CITY OF BURBANK  
COMMUNITY DEVELOPMENT DEPARTMENT

**Subject:** Pickwick Gardens, SB 35 Initial Project Review at 921-1001 Riverside Drive

## SB 35 Criteria and Consistency Analysis

**OPTION 10**  
**CONCEPTUAL DENSITY STUDY**  
MARCH 17, 2021

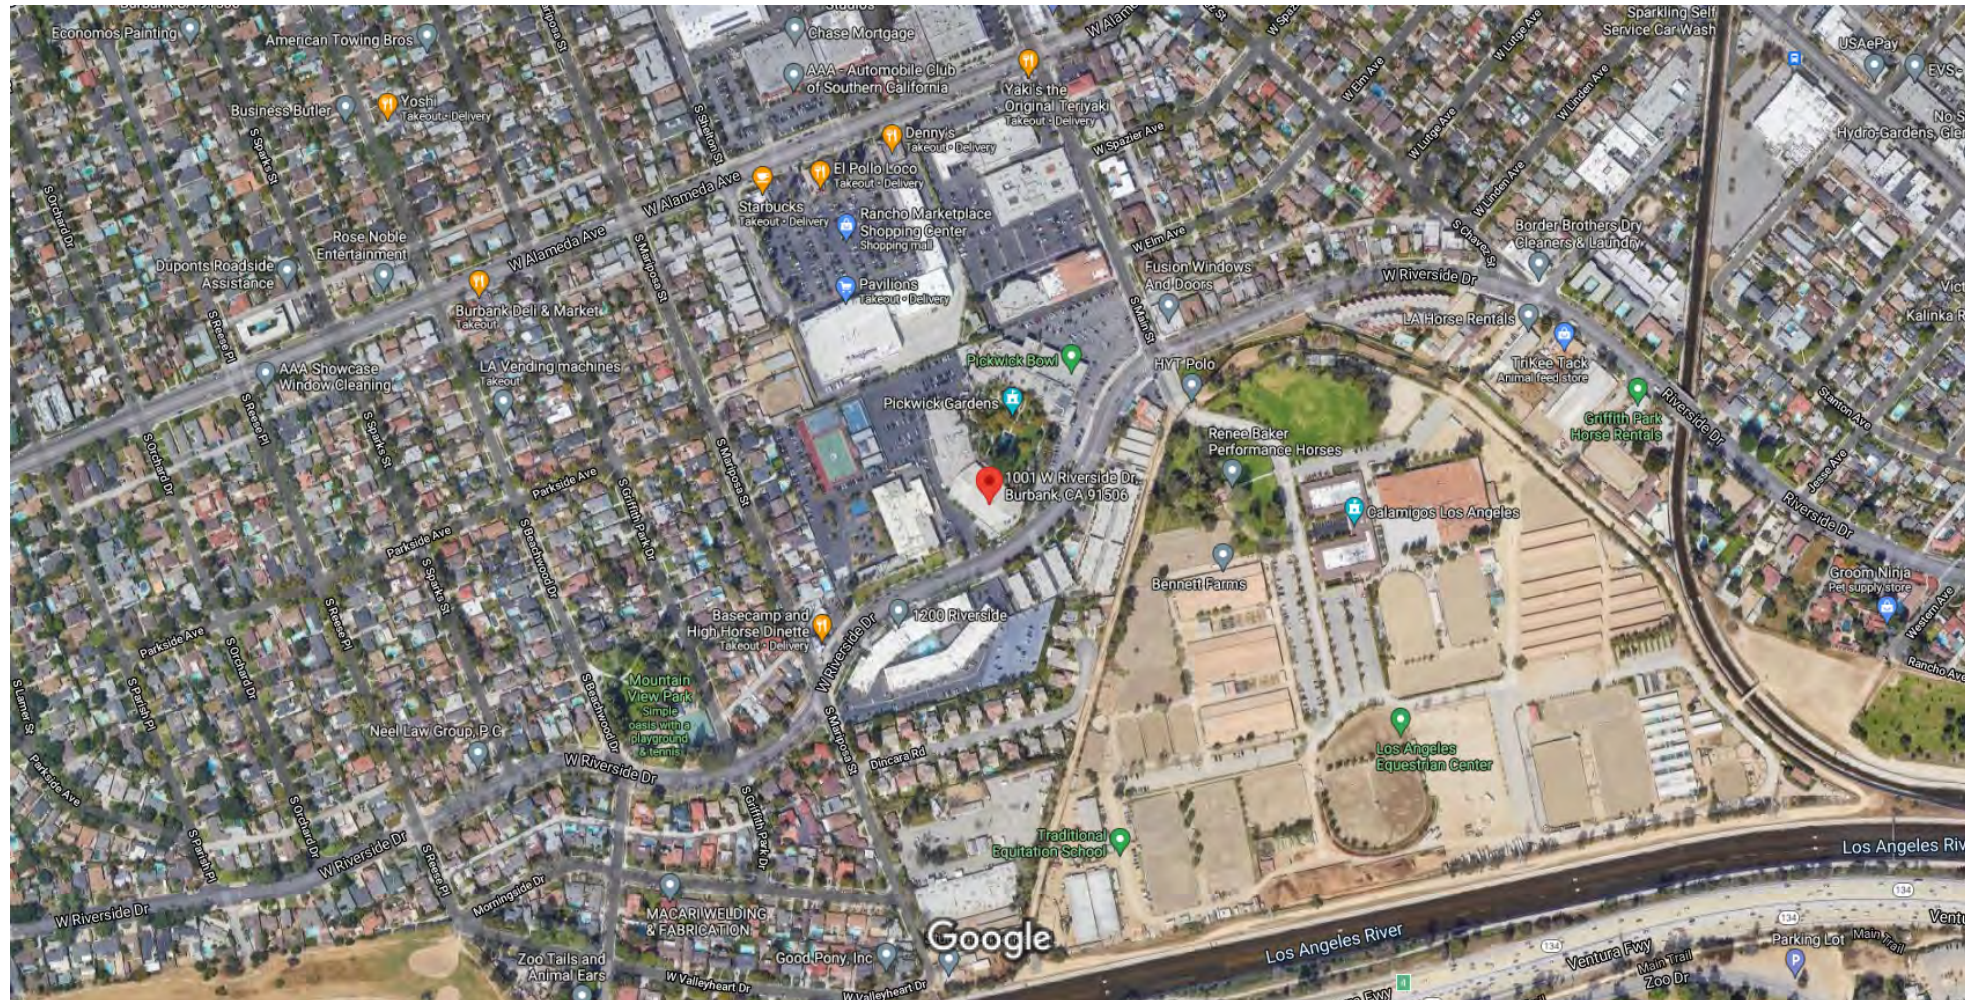
Please provide supplemental information via site plans, architectural plans, landscape plans, etc. supporting that the Project is consistent with the following objective development standards that were marked as incomplete in the attached Consistency Analysis (**see Attachment B**), applicable to landscaping, open space, parking area setbacks, and building design. Also, as noted above, **Attachment A** contains additional comments from City staff for your consideration as part of any future application that may be submitted after the completion of the NOI review and the Tribal consultation process.

<b>ARTICLE 24. RANCHO MASTER PLAN ZONES: DIVISION 6. COMMERCIAL RECREATION (CR) ZONE</b>	<b>Consistency Analysis</b>	<b>Consistency Determination</b>
<b>Maximum Residential Density.</b> 20 units/acre. (10-1-2436.5)	<p>The proposed density is 20.6 du/ac. Pursuant to the first footnote in Table 10-1-628(A) of the Municipal Code, for dwelling unit calculations, the number of allowed dwelling units is determined by rounding down to the nearest whole number even when the fraction is 0.5 or greater. Thus, the allowed number of units on the 4.7-acre site at 20 units per acre is 94 units. However, the Applicant has committed to adjusting the number of units in consultation with City staff to ensure compliance with this provision, and may request a density bonus in accordance with the State Density Bonus Law and the City's Inclusionary Housing Ordinance. Thus, the application does not conflict with the City's General Plan and zoning requirements.</p>	<b>Consistent</b>

ARTICLE 24. RANCHO MASTER PLAN ZONES: DIVISION 6. COMMERCIAL RECREATION (CR) ZONE	Consistency Analysis	Consistency Determination
(10) foot setback is required. A minimum five (5) foot setback from the rear lot line to any surface parking area is required. (10-1-2441.C.2.c)		
<b>Landscaping:</b> California native plants and California Sycamore trees shall be used as landscaping materials. California Sycamore trees shall be used as required street trees. The landscaping requirements of Section 10-1-705(C)(3) shall apply in the CR Zone. The requirements for parking structures and surface parking lots in Article 14 of this Chapter shall apply in the CR Zone. (10-1-2441.C.3)	The City required landscape palettes will be used in combination with a fully developed landscape architect's concept plan. The Project will comply with all applicable landscaping requirements.	<b>Incomplete</b>

<b>ARTICLE 24. RANCHO MASTER PLAN ZONES: DIVISION 6. COMMERCIAL RECREATION (CR) ZONE</b>	<b>Consistency Analysis</b>	<b>Consistency Determination</b>
<p>side yard, but may be permitted within the required interior side and rear yards.</p> <p>Trash enclosures shall be recessed or within the structure, or enclosed by a six (6)foot high masonry wall on three (3) sides and have a solid permanent metal gate(s).</p>		
<p>Section 10-1-1113.1: Commercial and Industrial Design Standards.</p> <p>H. Location and Screening of Trash Bins. Doors and gates of trash enclosures cannot swing out into any public right-of-way. If the lot abuts an alley, the trash bin must be directly accessible from the alley.</p> <p>I. This section deleted by Ord. No. 3548, eff. 9/2/00.</p> <p>J. FENCES AND WALLS.</p> <p>1. Height - Except as otherwise provided for property located at an intersection, the height of walls, fences and hedges may not exceed:</p> <p>a. Three (3) feet above the finished grade of the lot within any required front yard and within the required side yard on the street side of a corner or reverse corner lot; provided, however, that where a parking lot abuts or is across the street from a residential zone, a six (6) foot high masonry wall may be constructed within the required front yard and within the</p>	<p>The project does not include a trash enclosure.</p>	<p><b>Incomplete</b></p>

<b>ARTICLE 6. RESIDENTIAL USES AND STANDARDS</b> <b>Division 4 (Multiple Family Residential Zones)</b>	<b>Consistency Analysis</b>	<b>Consistency Determination</b>
<p><b>PARKING AREAS AND DRIVEWAYS.</b> (10-1-628.I)</p> <ol style="list-style-type: none"> <li>1. All parking spaces provided in a multifamily project, including tenant and guest spaces, must be full-size spaces no less than eight (8) feet, six (6) inches wide and no less than 18 feet deep.</li> <li>2. When individual garages or carports are used to provide parking for individual units, a clear space no less than nine (9) feet, six (6) inches wide and 19 feet deep must be provided inside the individual garage or carport for each parking space.</li> <li>3. All parking spaces must be clear of any encroachments including but not limited to structural features, shelves, cabinets, appliances, and equipment.</li> <li>4. Tandem parking spaces may be used only on projects with three (3) or fewer dwelling units in the multiple family zones, other than in the R-2 Zone. When tandem parking is used, at least one (1) tandem pair of parking spaces must be provided for each dwelling unit and each tandem pair must be assigned to a specific unit.</li> </ol> <p>Guest parking spaces may not be tandem spaces.</p>	<p>All open parking spaces have a minimum dimension of 8'-6" in width and 18 feet in depth.</p> <p>All garages have two side-by-side parking spaces and meet the minimum dimensions and provide at least 20 feet in width and 19feet, 6 inches in depth.</p> <p>All garages spaces are clear of all encroachments, including trashcans and appliances (including laundry).</p> <p>The project does not include any tandem parking spaces.</p>	<p><b>Incomplete</b></p>

- Proposed 26' wide driveway is too narrow for ingress and egress. Two-way driveway should be minimum 30' wide.
- Modify striping on Riverside Drive to provide exclusive left turn lane for driveway access.

- Provide a second point of egress on Main Street.
- Provide truck-turning template for refuse truck, showing that each unit's trash collection area will be accessible by refuse truck.
